STAFF REPORT

Case #31-17: SITE PLAN APPROVAL
61 John Vertente Boulevard
(Map 133, Lot 47)

The submittal is shown as the Site Plan for 61 John Vertente Boulevard (Assessors Map 133, Lot 47) New Bedford, MA dated August 10, 2017 prepared for Parallel Products of New England, 401 Industry Road, Louisville, KY 40208 by Farland Corp., 401 County Street, New Bedford, MA 02740, consisting of nine (9) sheets;

COVER SHEET
SHEET 1 OF 9

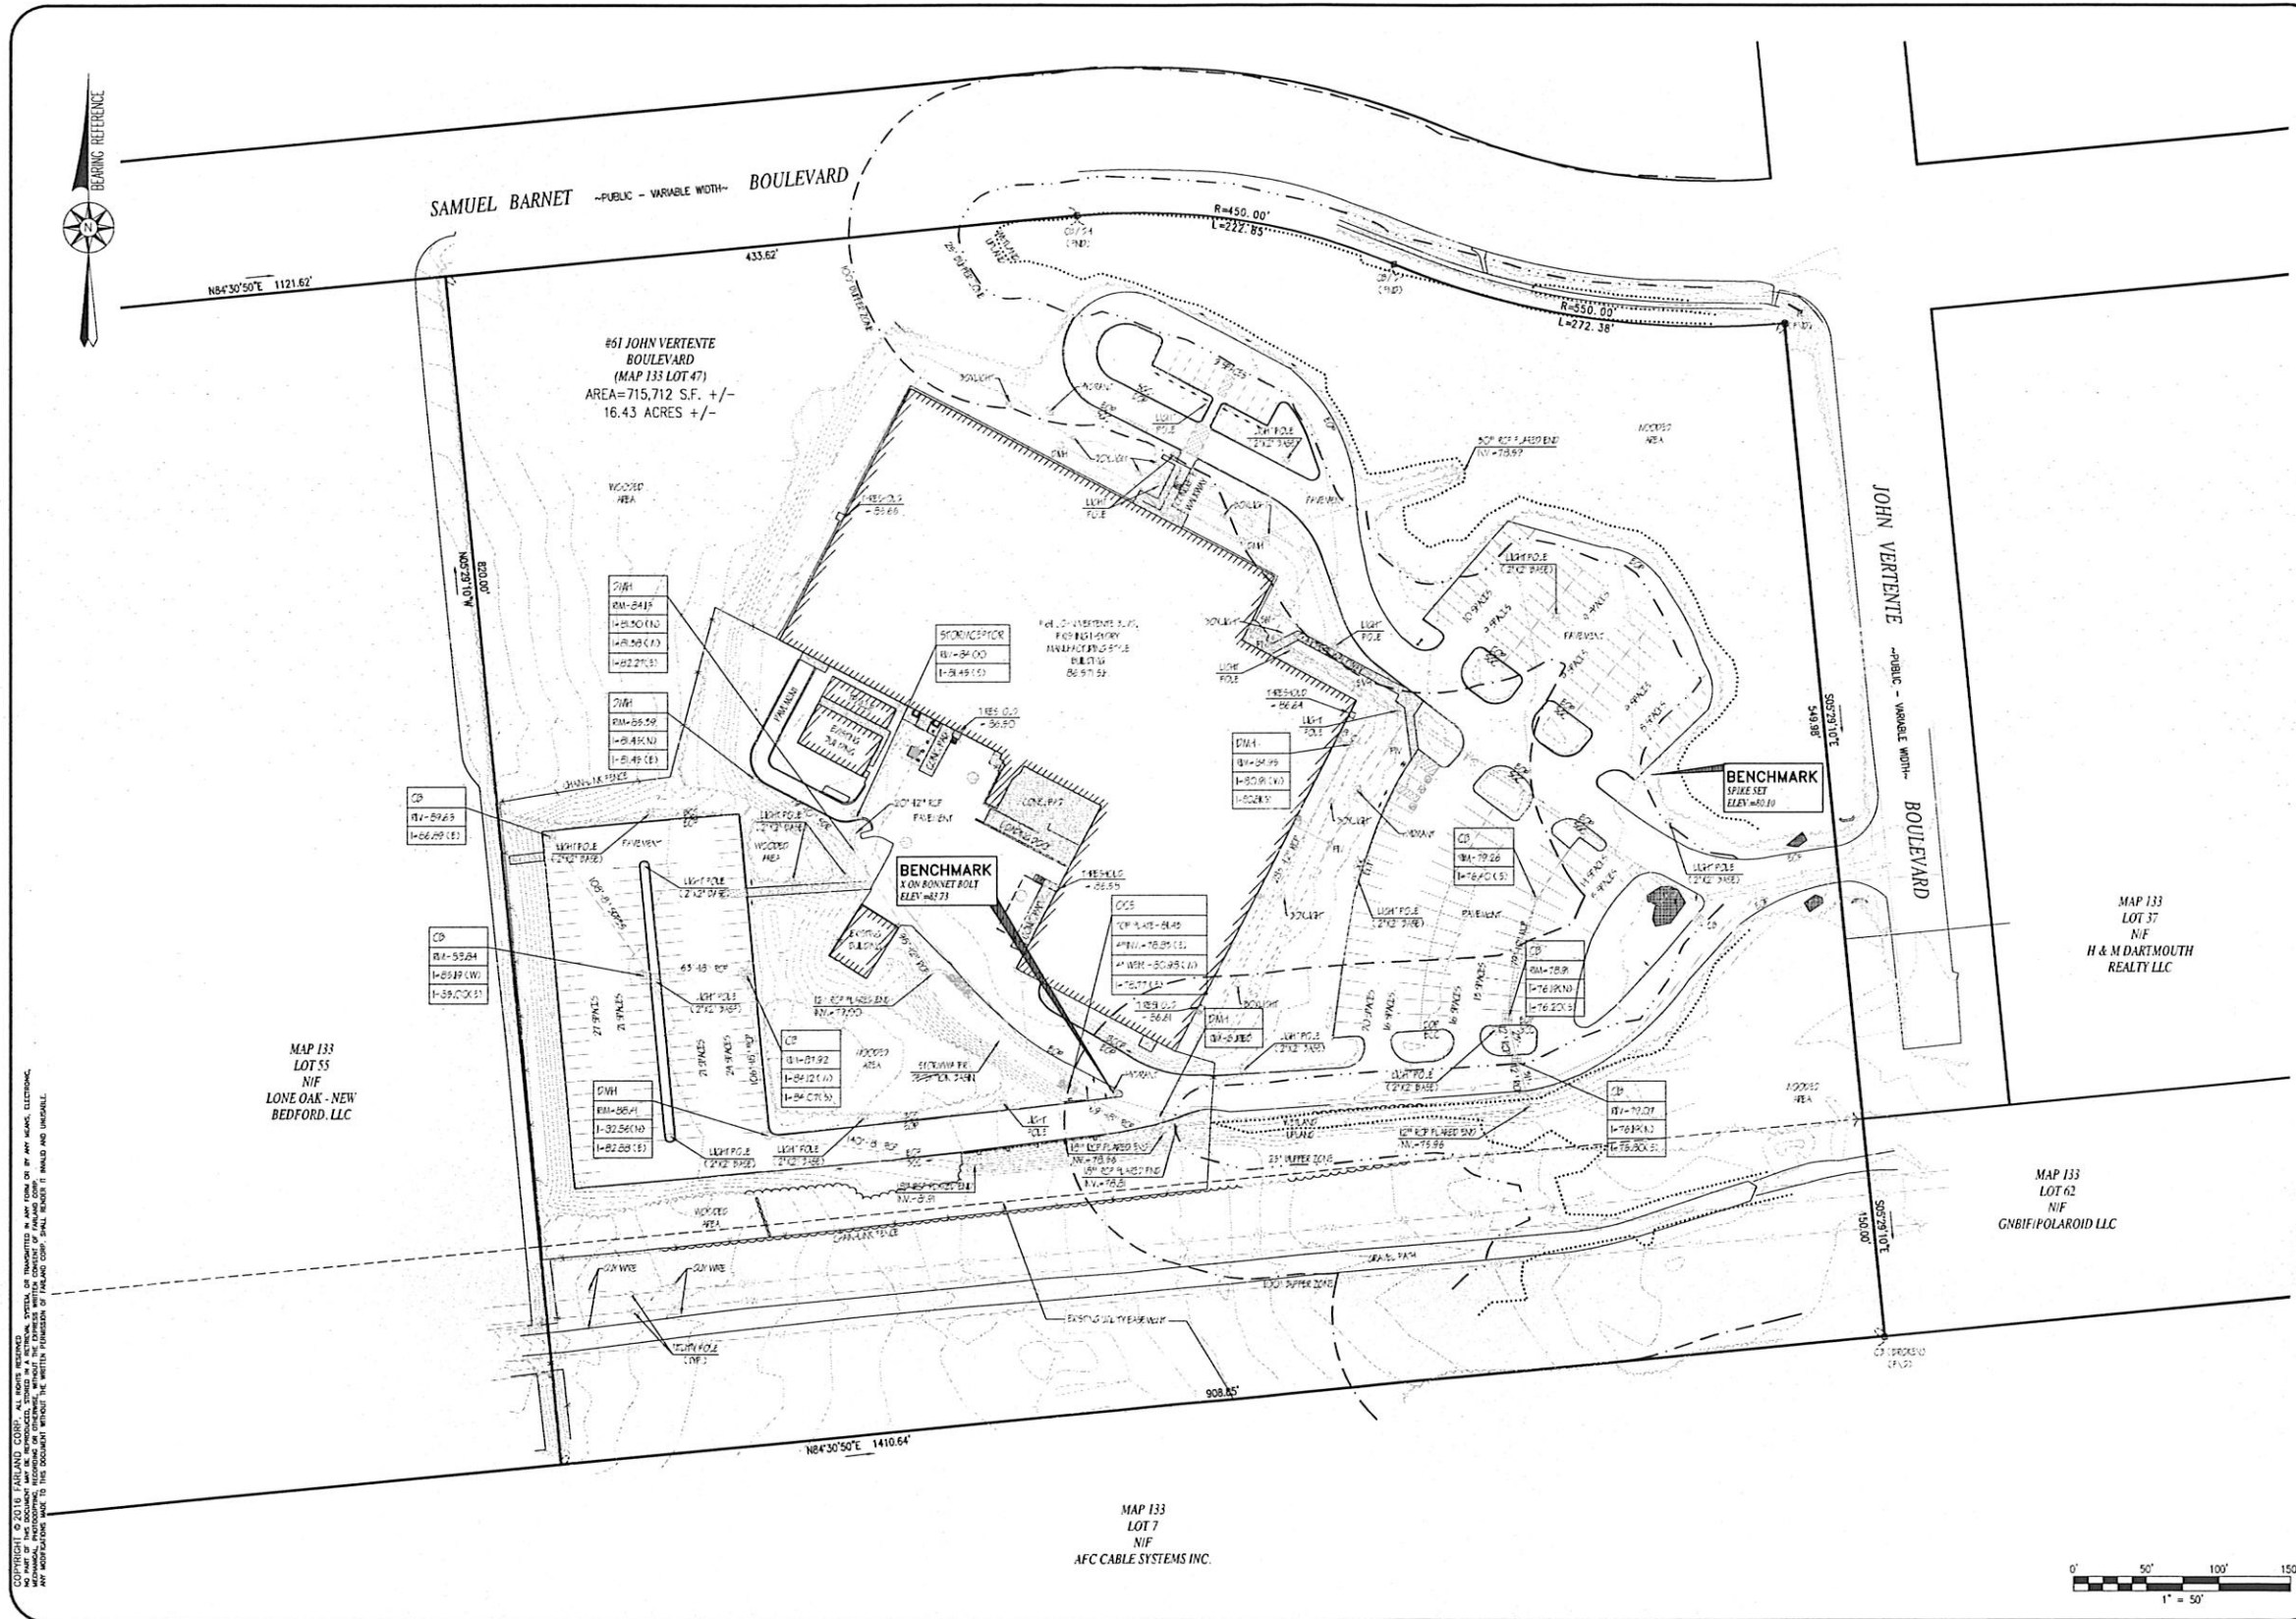
- ☐ The Zoning Matrix on the Cover plan sheet shall be amended to note the GNBIF Regulations for building coverage for first floor square footage shall not exceed 40% of the total area of the premises [as per Item 1 of the GNBIF Regulations].

- ☐ The Zoning Matrix on the Cover plan sheet shall be amended to note the GNBIF Regulations for lot coverage, to include all uses on a lot which include, but are not limited to, buildings, driveways, parking areas, impermeable surfaces, etc., shall not cover more than 65% of the total area of the premises [as per Item 2 of the GNBIF Regulations].

- ☐ The Zoning Matrix on the Cover plan sheet shall be amended to note the GNBIF Regulations for setbacks, which are fifty (50) feet from any street or lot line [as per Item 7 of the GNBIF Regulations].

- ☐ Add **Waivers**.
- ☐ Zoning Data on the plan set Cover Sheet state the applicant has provided 153 parking spaces, eight (8) ADA spaces, and 18 loading dock spaces. Please recheck calculations. Inconsistencies should be corrected on plan sheets, Project Summary, and application form.

SHEET 2 OF 9

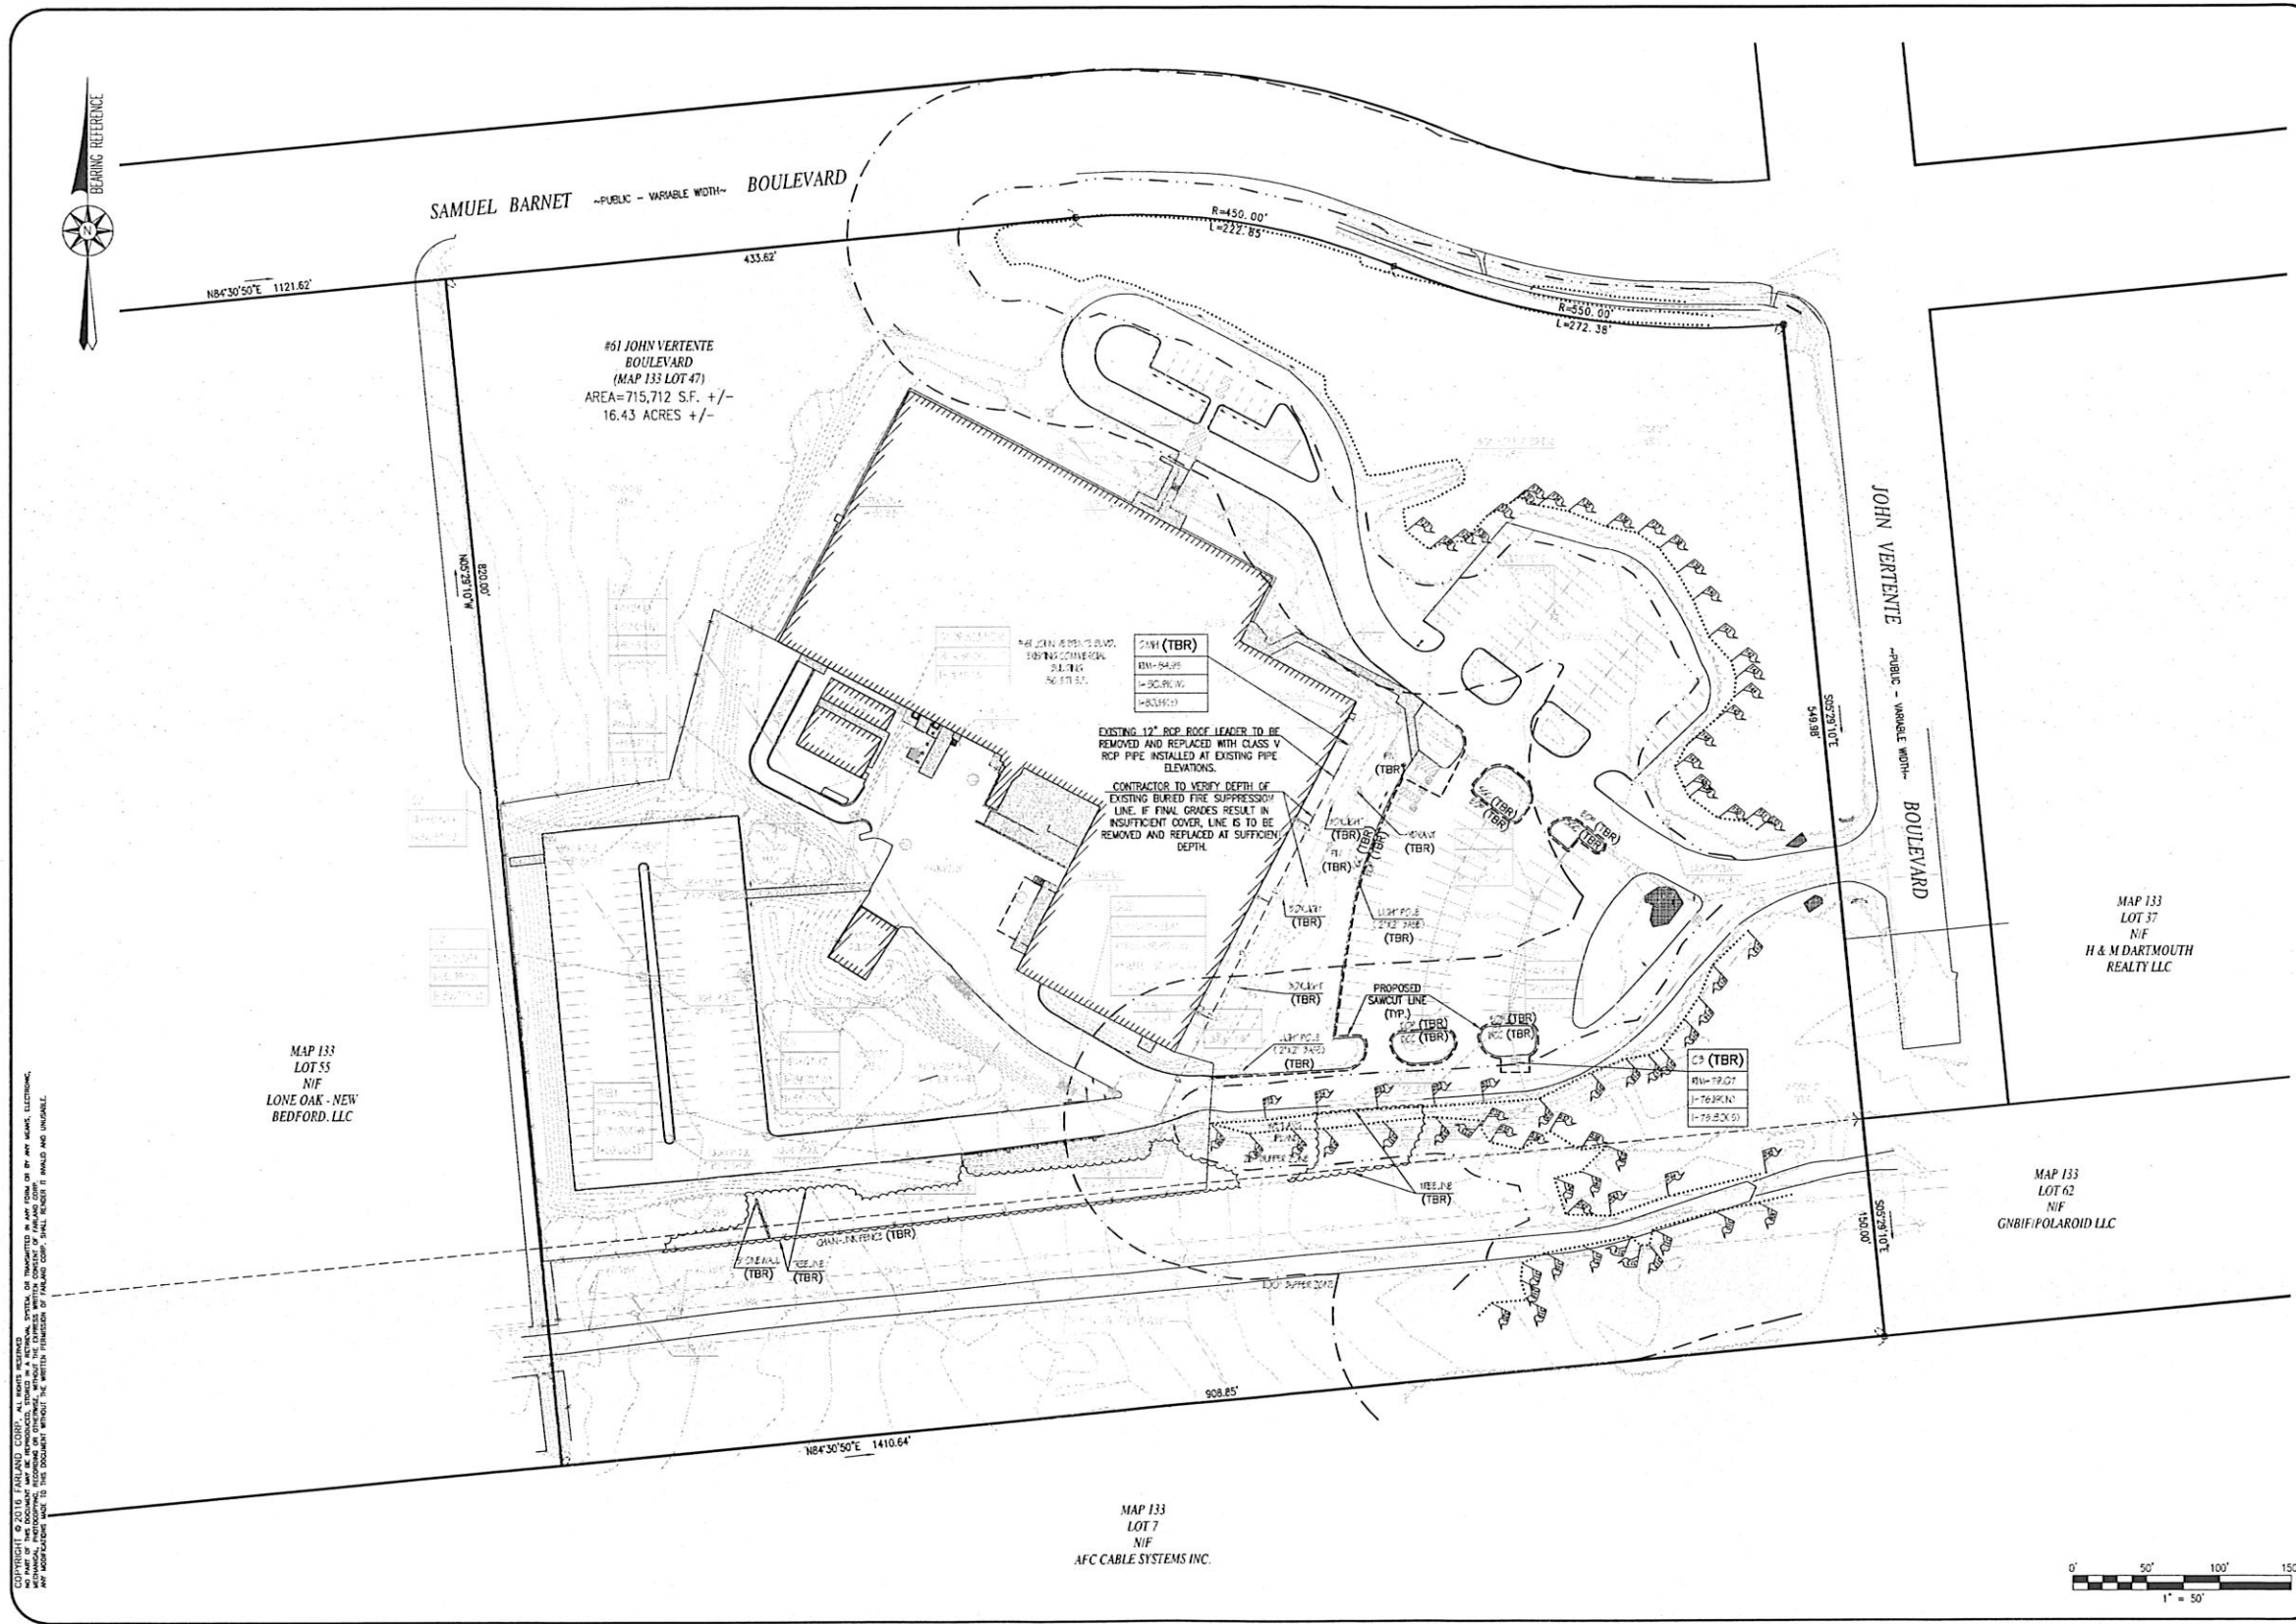
- ☐ If a Deed Book and Page number is available for utility easement, this should be included on revised plans.
